# UNITED STATES PATENT AND TRADEMARK OFFICE

APPLICATION NO.	FILING DATE	FIRST NAMED INVENTOR	ATTORNEY DOCKET NO.	CONFIRMATION NO.
10/780,587	02/19/2004	Takashi Watanabe	023971-0377	2484
22428 7590 11/08/2007 FOLEY AND LARDNER LLP SUITE 500 3000 K STREET NW WASHINGTON, DC 20007			EXAMINER PILKINGTON, JAMES	
			ART UNIT 3682	PAPER NUMBER
			MAIL DATE 11/08/2007	DELIVERY MODE PAPER

# Office Action Summary

Fig. 4.

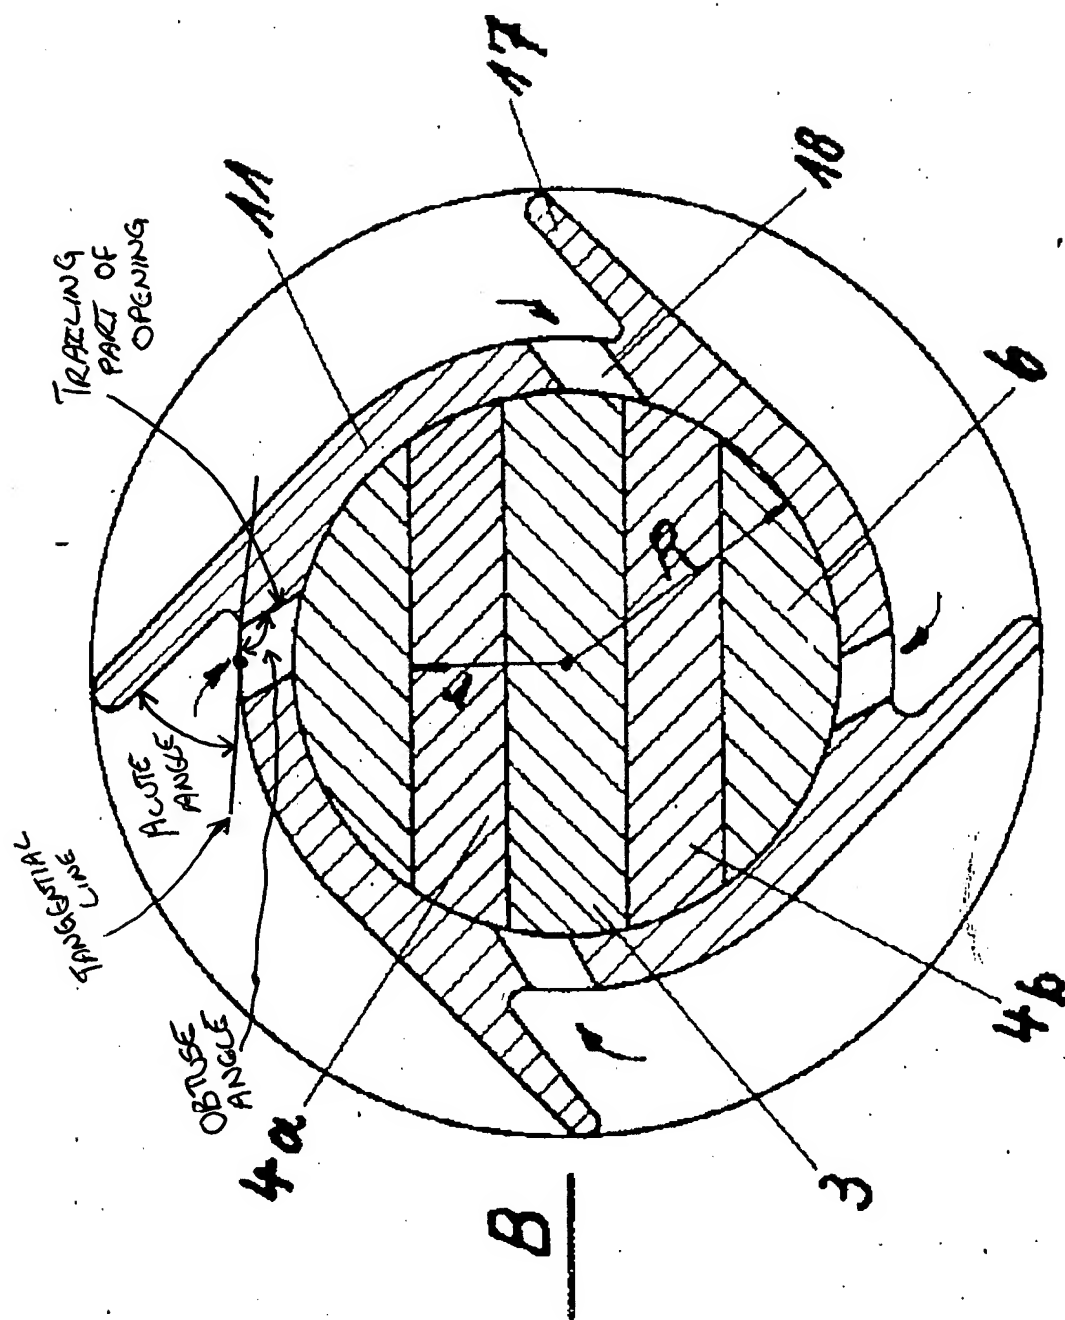
pinion shafts (the vanes 17 extend out from the recess holding shaft 1' and extend from the recess for shaft 12 to that for shaft 1), the first projection portions (17) having an inclined surface (the vanes 17 are sloped), the inclined surface defining an acute angle relative to a tangential line of the outer surface at a center point of the projected portion (see Figures 1 and 2 where the vanes are shown as acute angles or see the Figure at the end of this action)
